**SAN DIEGO REGIONAL WATER QUALITY CONTROL BOARD
DRAFT MS4 PERMIT: A CASE STUDY**

*Dennis Bowling, PE, MS; Mark Grey, Ph.D; Luis Parra, Ph.D, PE, MS, CPSWQ, ToR,
D.WRE; Tory Walker, PE, CFM; Shawn Foy Weeden, GE, PE*

On March 27, 2013, the San Diego Regional Water Quality Control Board (Region 9) (“RWQCB”) released its Revised Tentative Order No. R9-2013-0001 (National Pollutant Discharge Elimination System (NPDES) Permit and Waste Discharge Requirements for Discharges from the Municipal Separate Storm Sewer Systems (MS4s) Draining the Watersheds within the San Diego Region) (hereafter, “Revised Draft Permit”). This article analyzes four components of the Revised Draft Permit, and identifies concerns with the Revised Draft Permit’s treatment of those components based on the evidence that was before the RWQCB during its crafting of the Revised Draft Permit. The four components of the Revised Draft Permit are: hydromodification BMP requirements, the identification of a “pre-development” condition, Low Impact Development and the removal of pollutants in lieu of retaining stormwater onsite, and sediment transport requirements.

Photo 7 mid-rise condo project at the NW corner of 4th and Nutmeg, San Diego

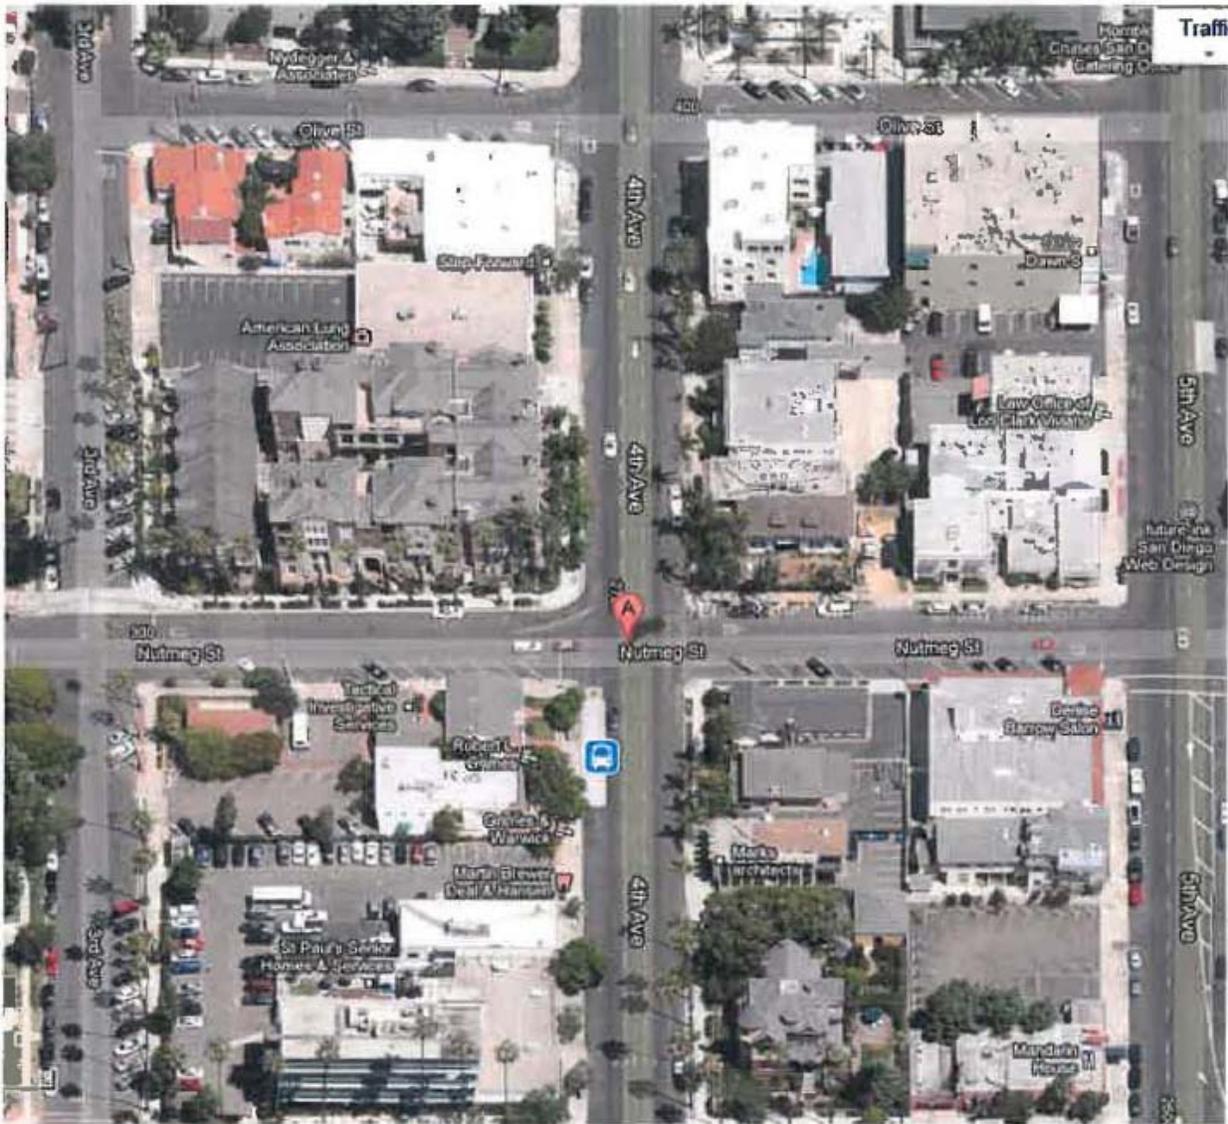
hydromodification exemptions on infill development render these projects both technically and financially infeasible. (Refer to photograph 7.)

Photo 7 shows a smart growth project on the northwest corner of 4th & Nutmeg in San Diego's highly urbanized Banker's Hill neighborhood: transit friendly (transit oriented development, TOD); walkable neighborhood; near parks, shopping and recreation (2 blocks from Balboa Park); near San Diego's airport; near Downtown/Hillcrest/Mission Valley work environments; and within the Smart Car (car 2 go) user footprint. Under the Revised Draft Permit, this project would become infeasible because of the 100% pollutant capture (infiltration/reuse) requirement and the loss of the hydromodification exemption previously included in the HMP.

The soil type at this location will not allow for infiltration. Additionally, to achieve the requisite density there is not enough land available to allow for supersizing of BMPs. There is no place to put a retention tank except under the building's parking structure. It may be infeasible to place a
